**Anchor QEA Memorandum  
“Response to U.S. Army Corp of Engineers’ Request  
for Additional Information”**

**To:** Erin Legge, U.S. Army Corps of Engineers      **Date:** March 28, 2013  
**From:** Heather Griffin, City of Everett  
Heather Page, Anchor QEA, LLC  
**Re:** Kimberly Clark DWO Project (NWS-2000-34)  
Response to U.S. Army Corps of Engineers' Request for Additional Information

Figure 1: Pre-Construction (left) 2001 and Post-Construction (right) 2011 Aerial Photography of Project Site  
Depp Water Outfall Beach Repair Project

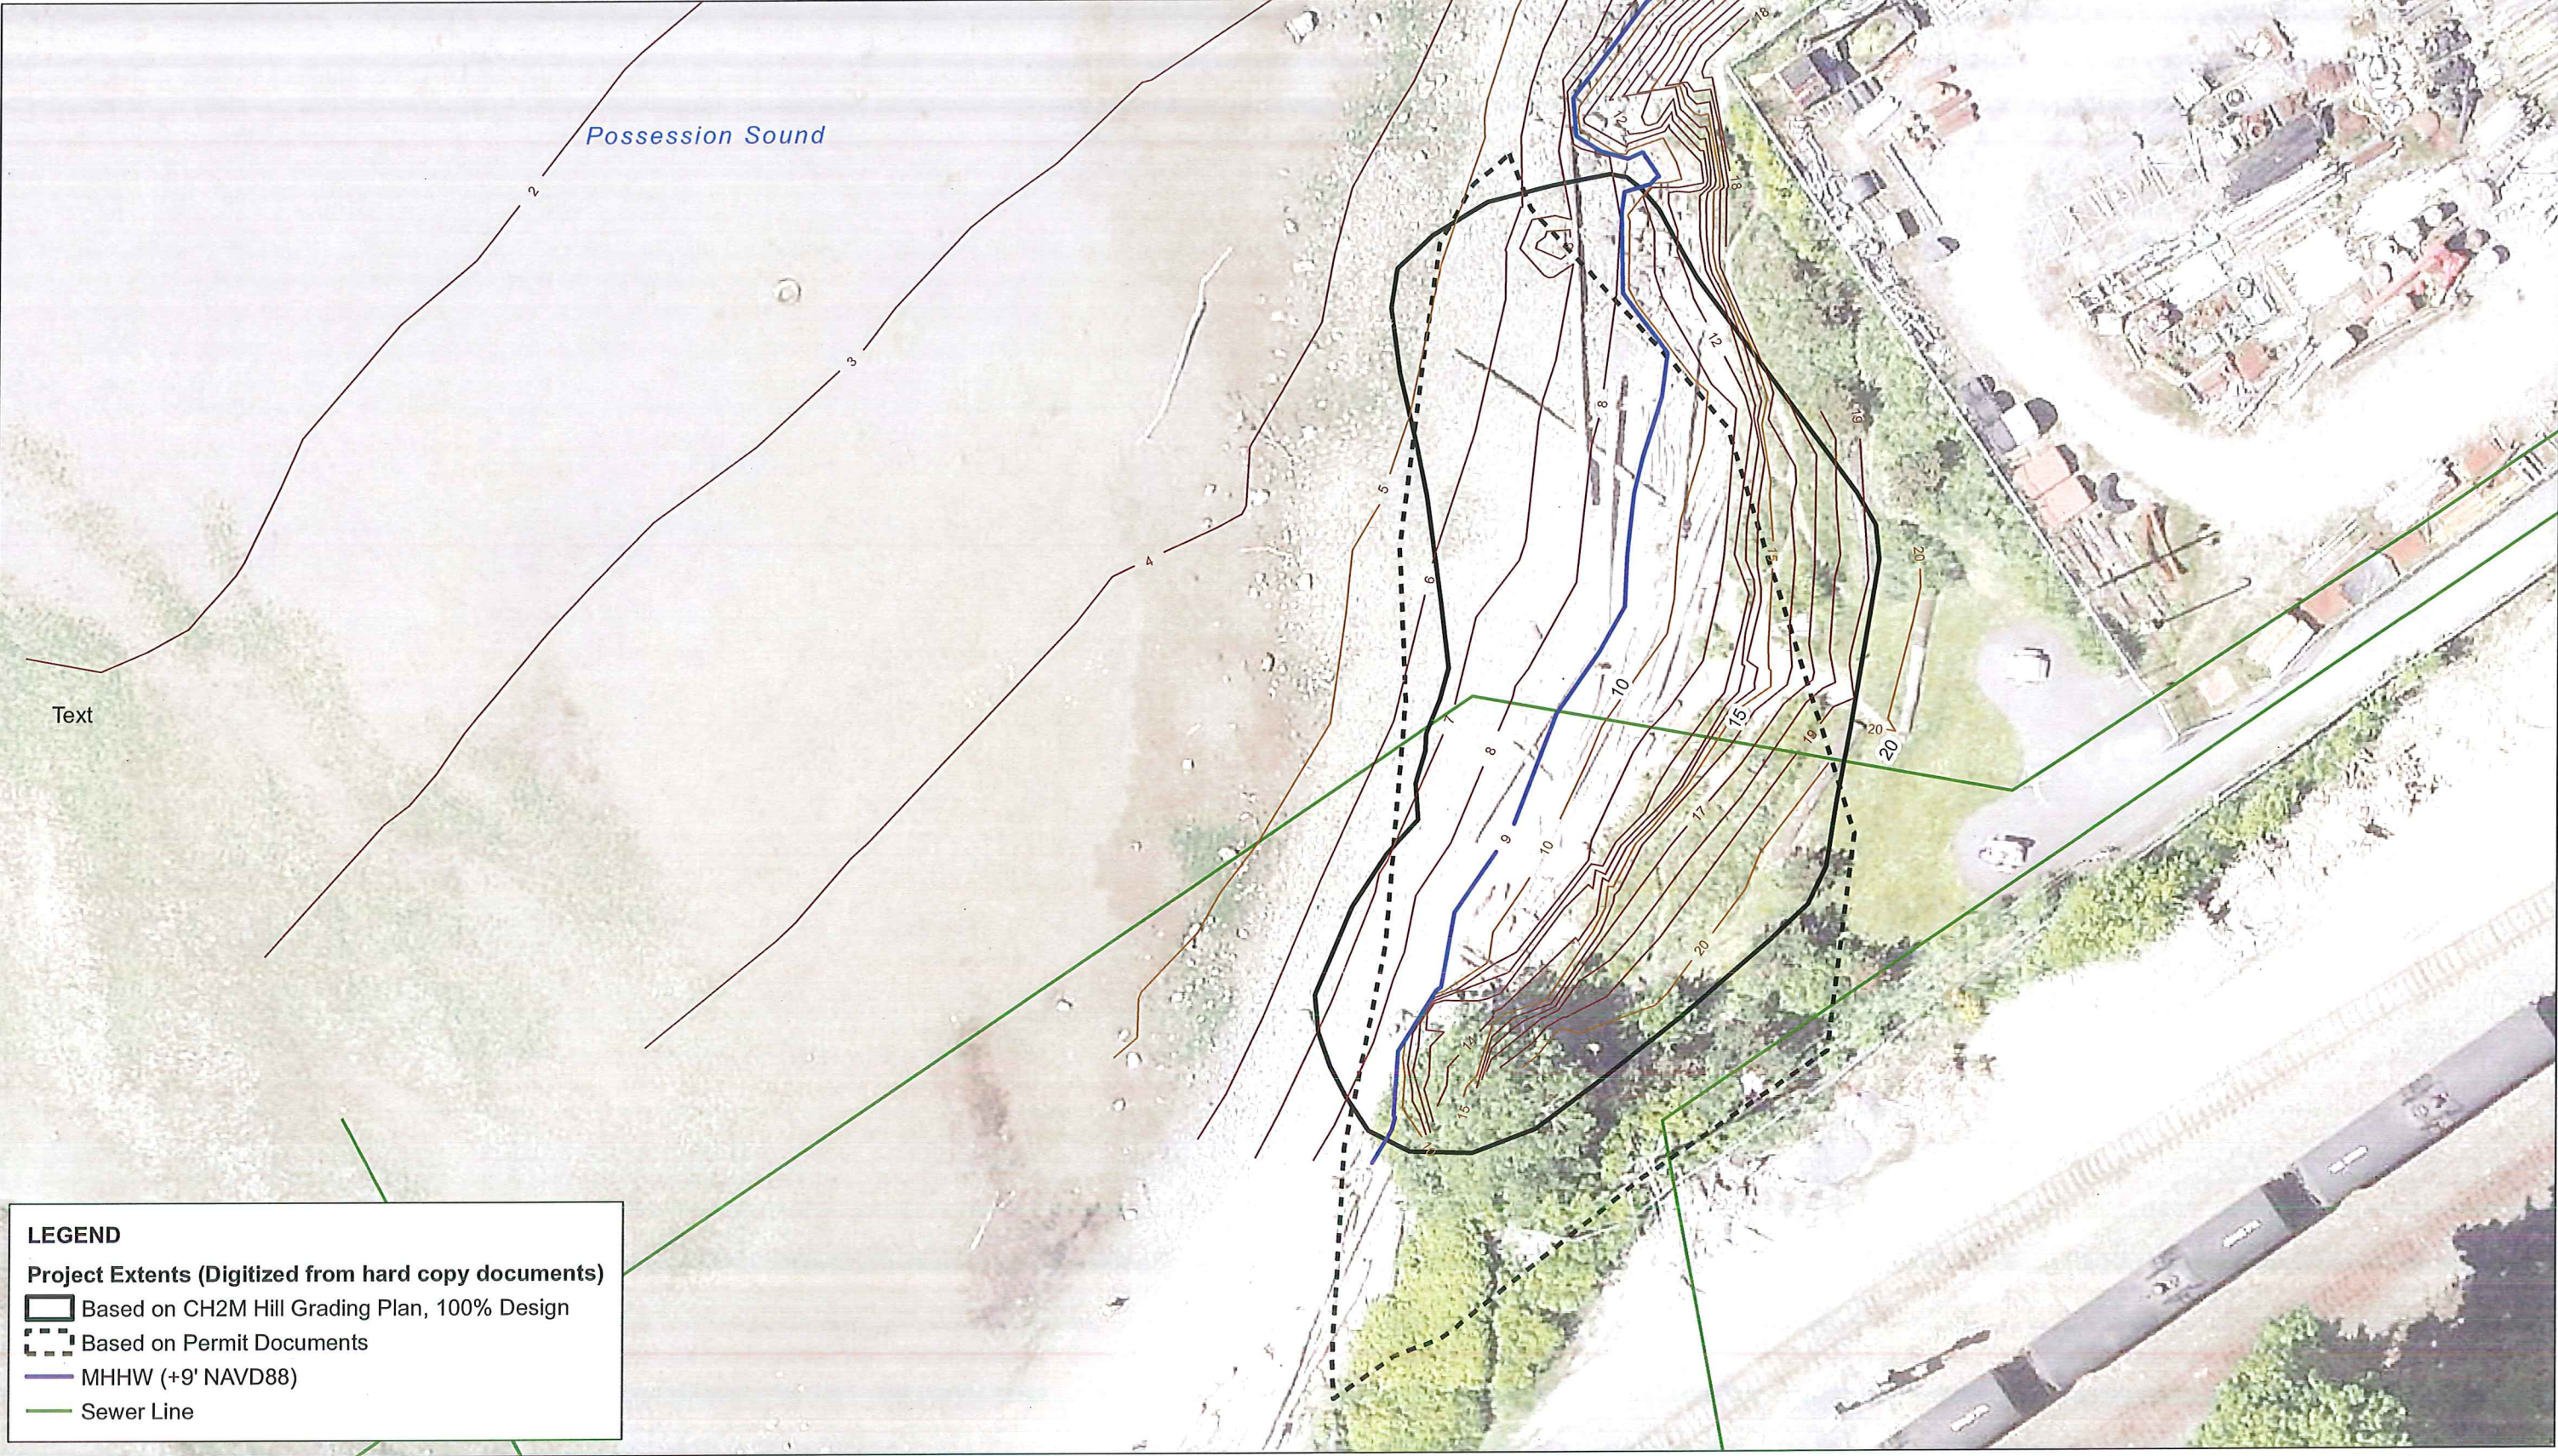
The site was originally uplands and was part of the Port of Everett (Port) as a laydown yard. It extended from the current northwest corner of the Port's laydown area to the southern portion of the project extent (see Figure 1 in Attachment 1).

**Figure 5**  
Plan View, Phase 1  
Deep Water Outfall Beach Repair Project

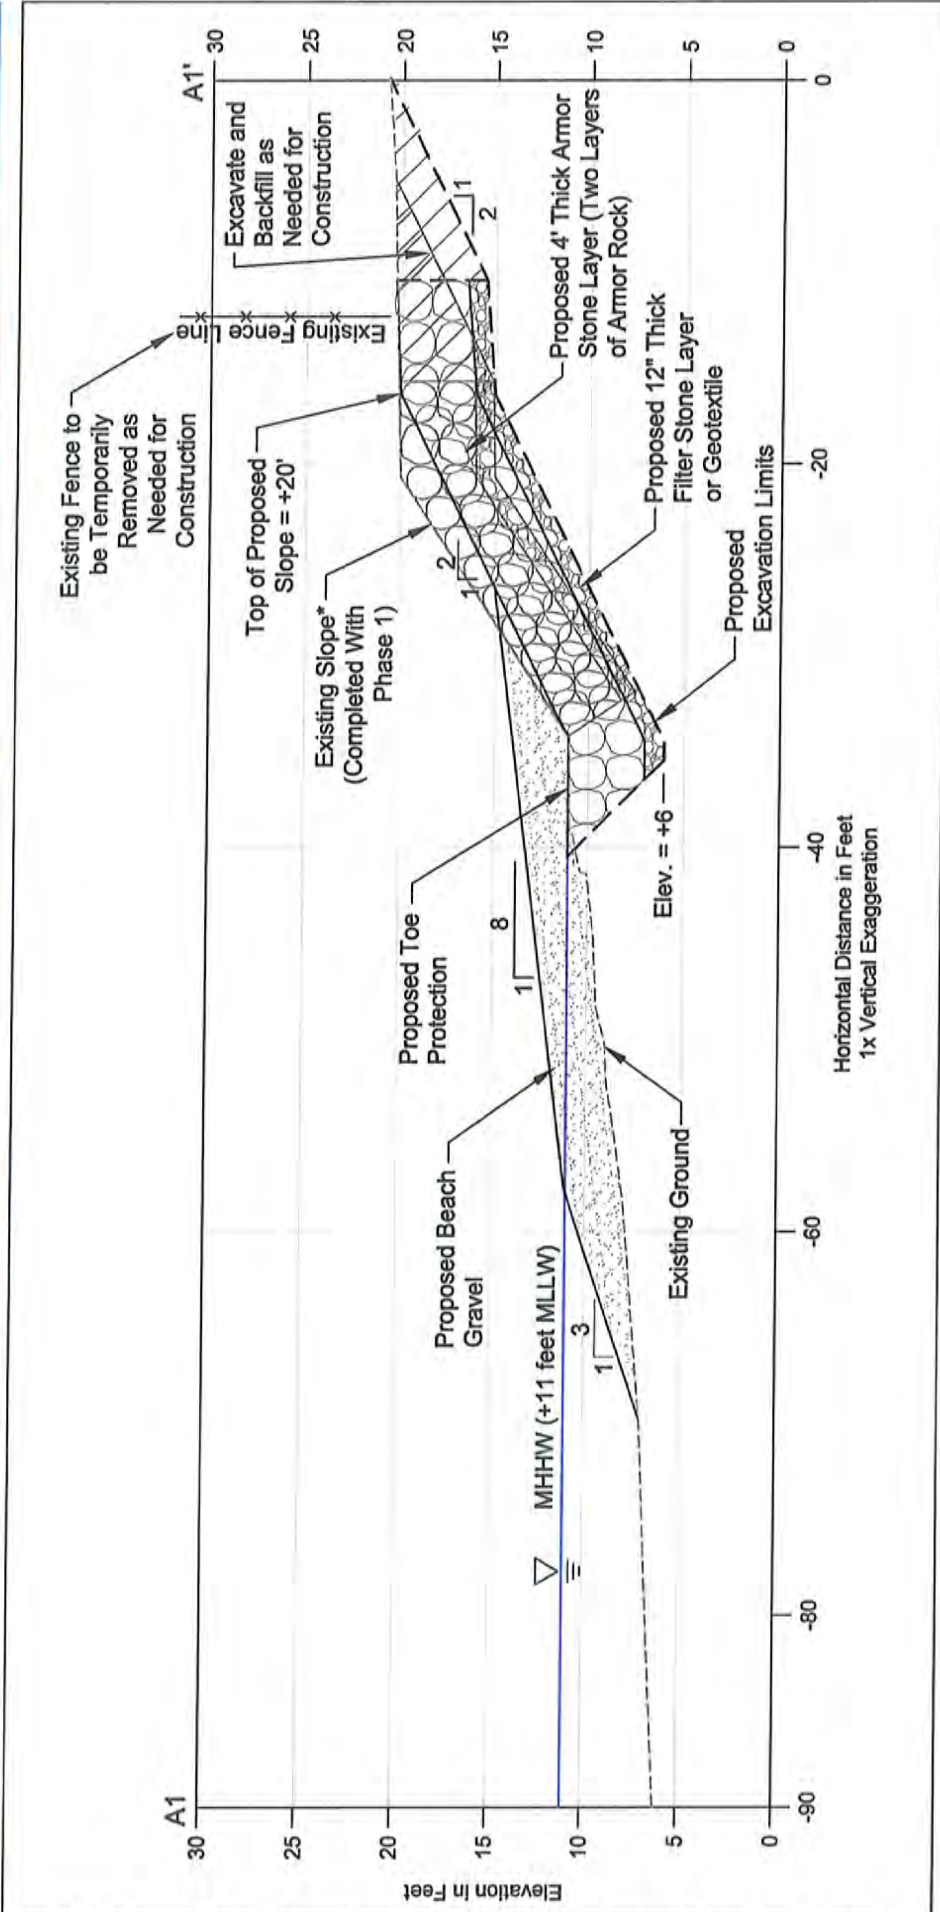
Phase 1 consisted of armoring the slope immediately adjacent to Port property (1,500 square feet; see Figure 5 in Attachment 1) above the existing MHHW. In addition to the eroded condition of the beach described above in "Original Beach Restoration," a storm on January 26, 2012, destabilized this area and threatened the slope's stability. Under the terms of their easement with the Port, KC needed to repair the beach as soon as possible, as further erosion may have led to additional slope destabilization throughout the site and possible property damage to Port property on the north side of the slope.

Approximately 300 cubic yards of armor stone (4 feet thick) and 75 cubic yards of filter stone (1 foot thick) were placed to stabilize the slope. To construct the slope, approximately 400 cubic yards of mixed sand/cobble material and armor stones were excavated and disposed of or reused as appropriate. Prior to construction, State Environmental Policy Act and Shoreline Substantial Development Permit Exemptions were obtained from the City of Everett Planning and Community Development. This project was completed in 4 days in December 2012.

**Figure 6**  
 Cross Section of Phase 1 / Phase 2 Overlap  
 Deep Water Outfall Beach Repair Project

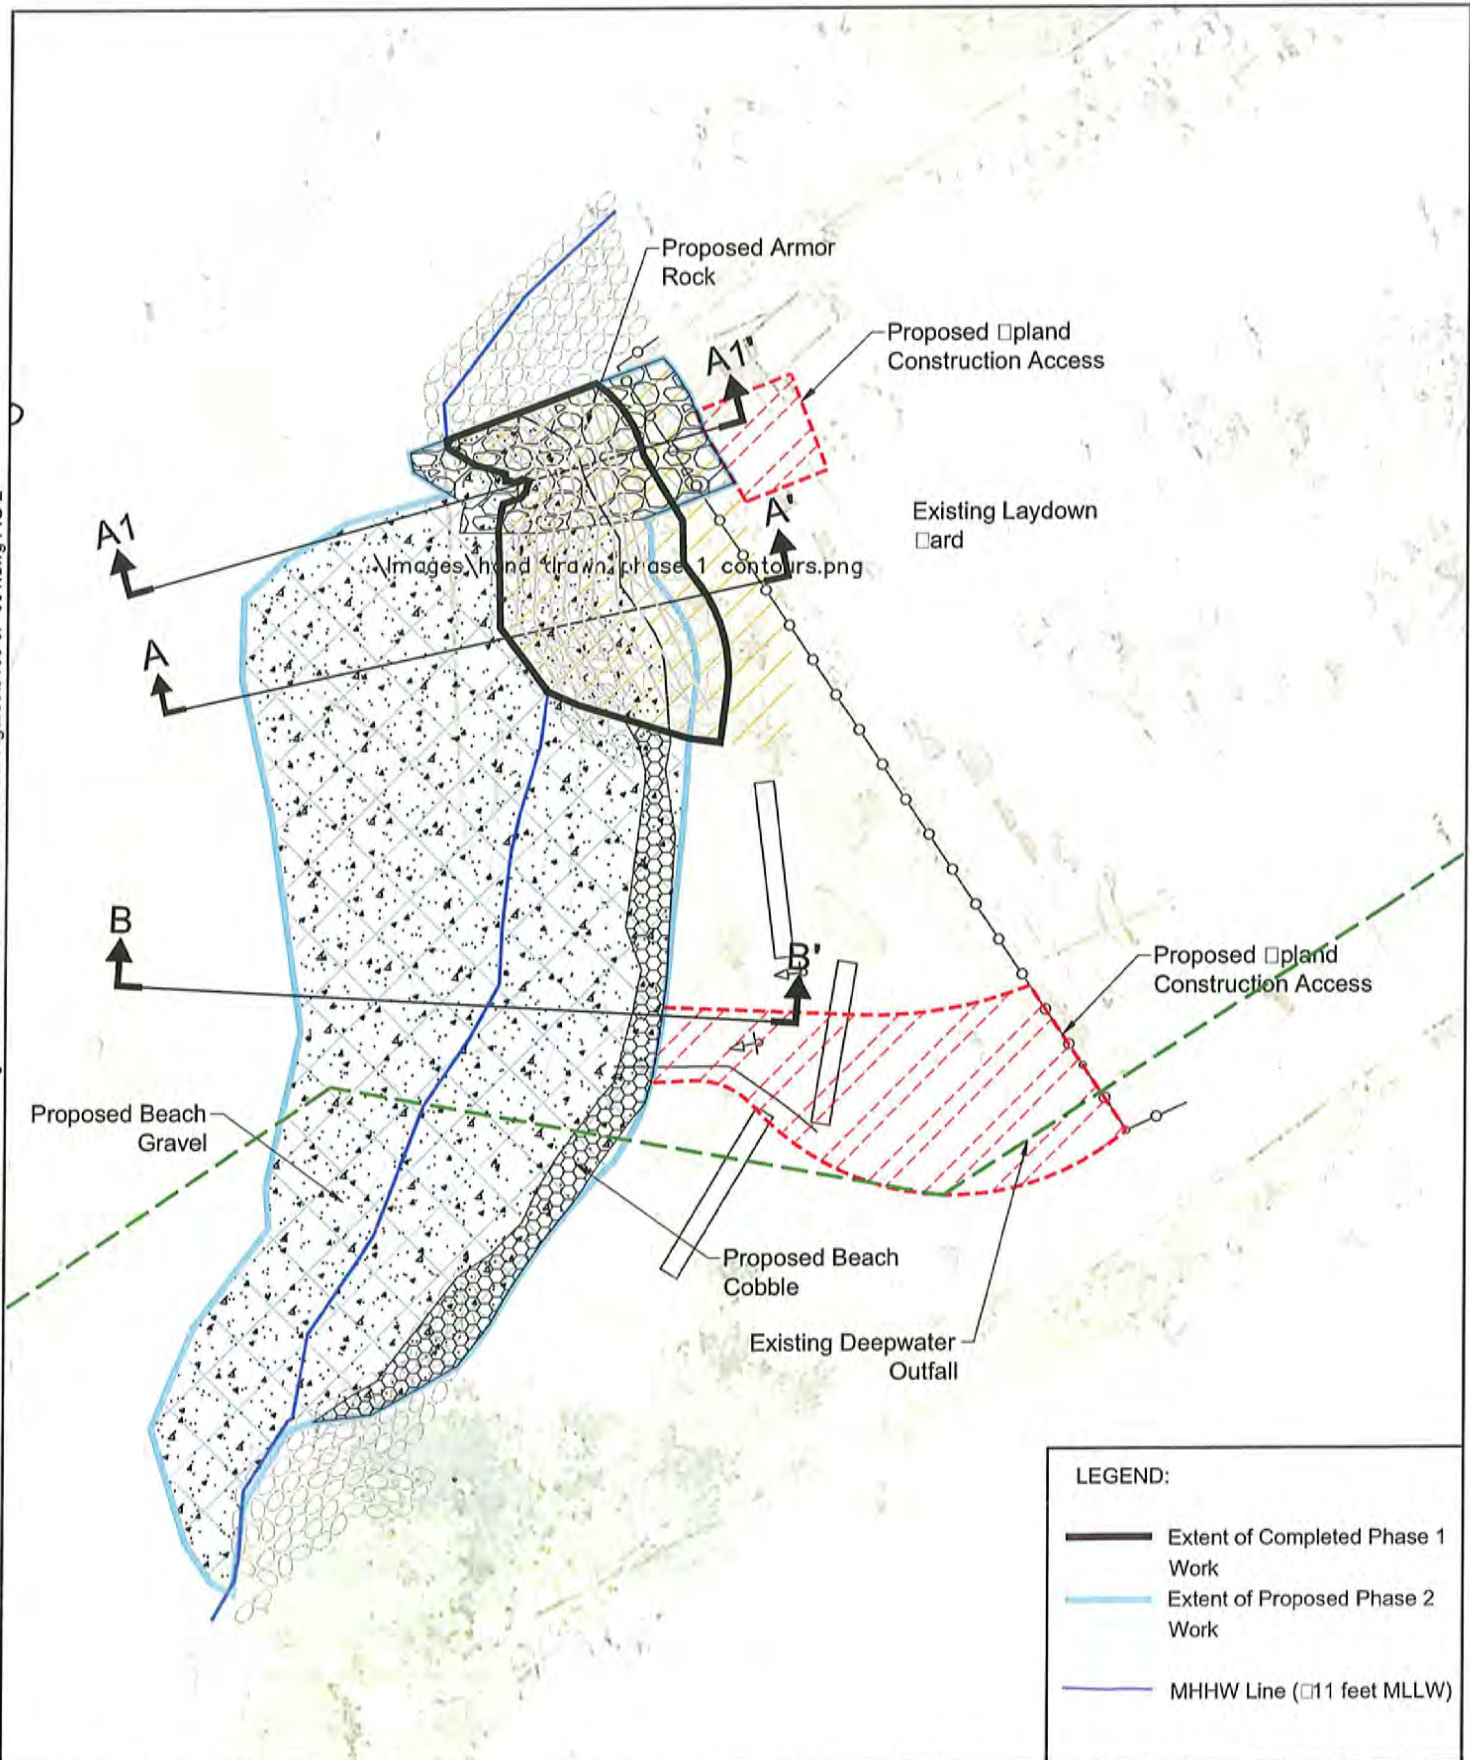
Phase 2 consists of adding additional toe protection to portions of the Phase 1 slope above and below MHHW (see revised Sheet 2 of the Joint Aquatic Resource Permit Application [JARPA] Drawings in Attachment 2). See Figure 6 in Attachment 1 for a cross-section of the overlap between Phase 1 and Phase 2. The toe of the slope from Phase 1 will be extended 50 square feet beyond MHHW to the extent required to build a stable rock revetment to stabilize that area. The revetment would also be modified from the 1.5H:1V slope for the Phase 1 construction, to achieve a 2H:1V slope for the final Phase 2 construction. Please see the JARPA submitted to USACE for a complete description of Phase 2 (City of Everett 2012).
